Applicant: Andrew Walser; Walser Real Estate, LLC
Consultant: Nick Adam; Rehder and Associates, Inc.
Project: Walser Toyota Redevelopment
Location: 4401 and 4217 American Boulevard West: Bloomington
Rule(s): 3, 4 and 5
Reviewer(s): LLH/BCO

General Background & Comments

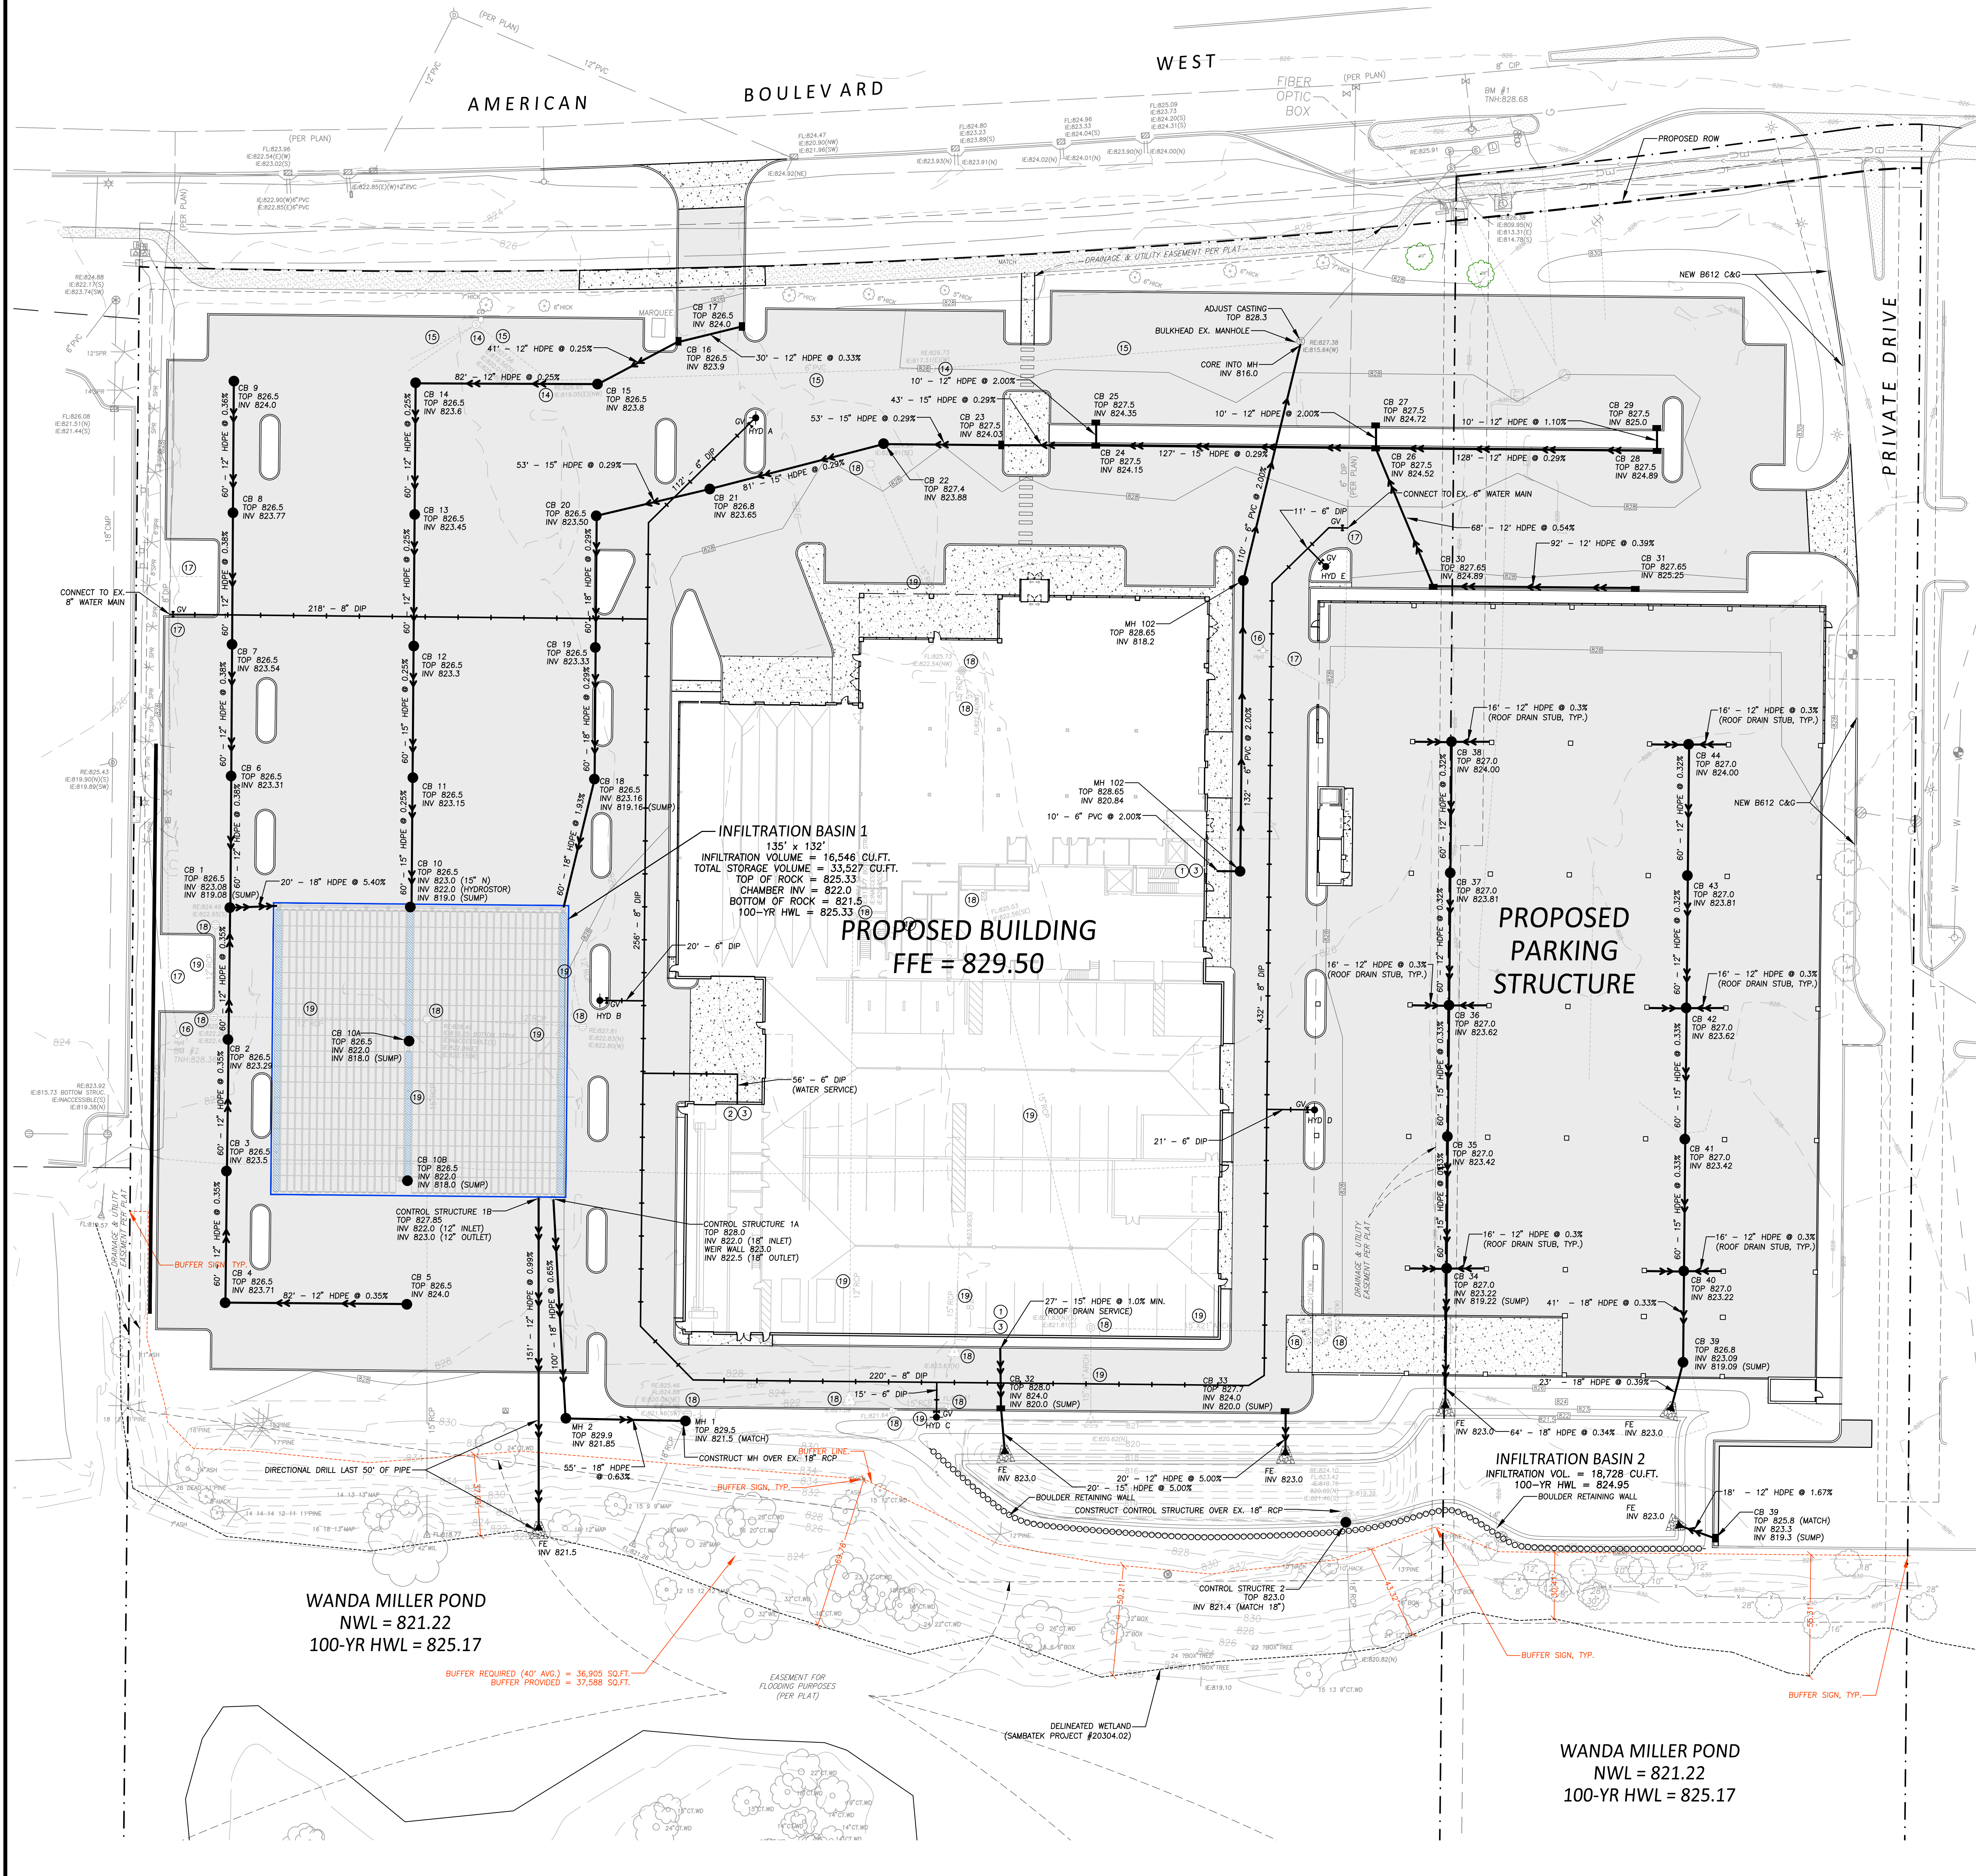
5. A method for controlling sediment from leaving the site at the construction entrance must be identified on the Grading, Drainage, Erosion Control and SWPPP Plan (Sheet C2).
